**ADDENDUM NUMBER TWO**

**RFQ # 7449351**

**TITLE: RESTORATION OF THE EISENHOWER HOUSE,  
NEWPORT, RI**

FIRST FLOOR PLAN

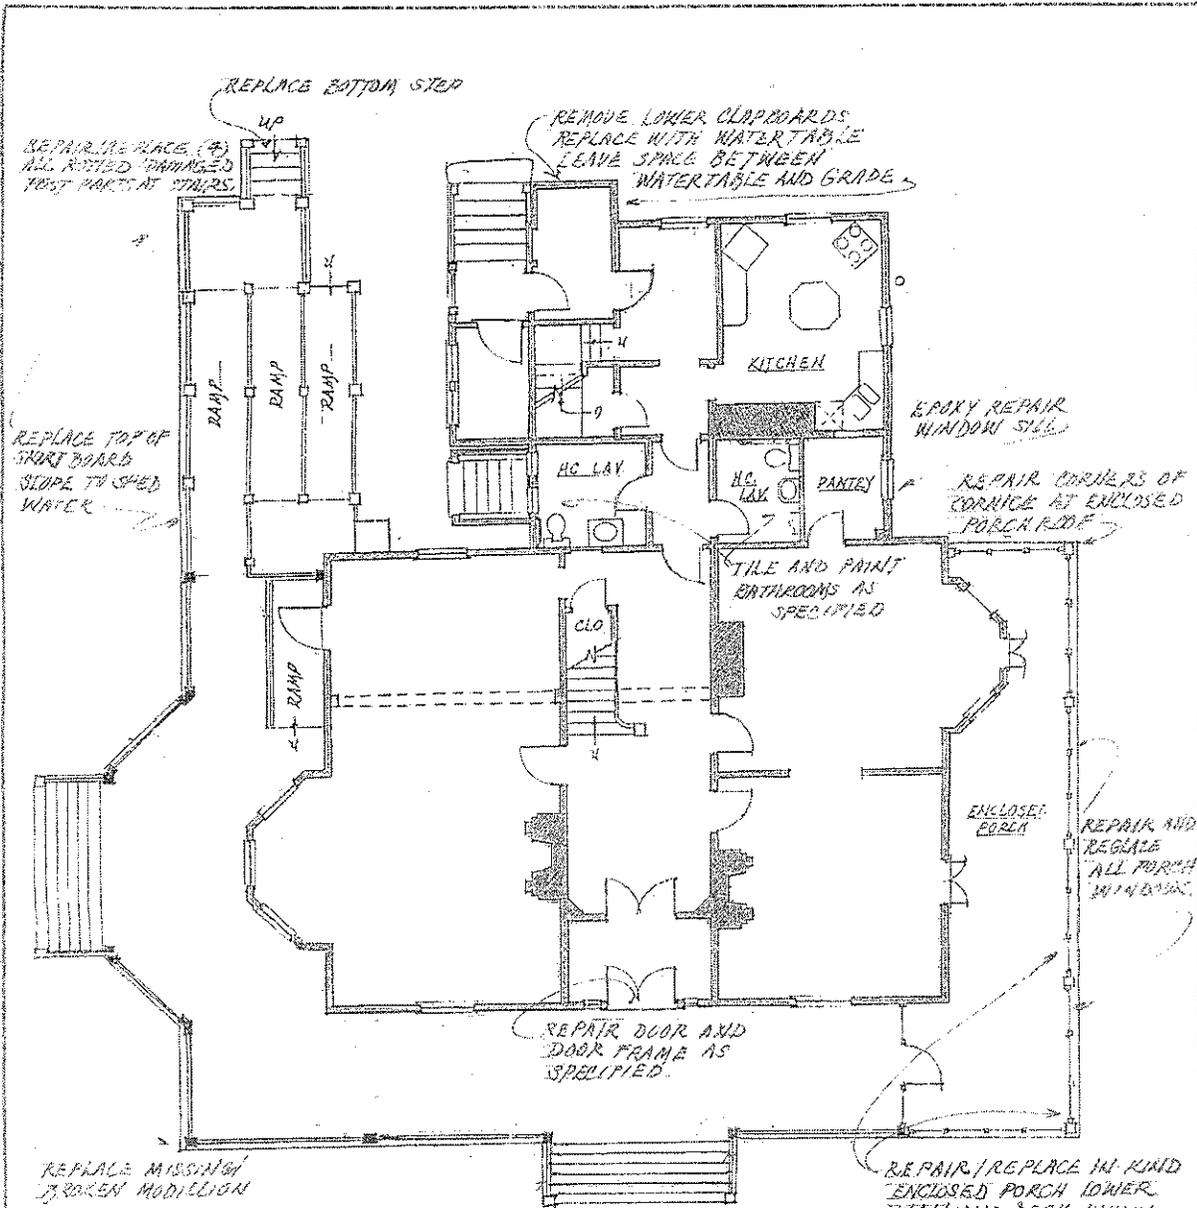
6. Division 8 –Doors & Windows - Section V - Part G: Please specify the amount of sidelight to be repaired/reglazed 'as needed'

*The sidelights are narrow sidelights on either side of the front door The panels at the bottom need to be repaired The work is minimal The glass panes all need to be reglazed The contractor should inspect this on site*
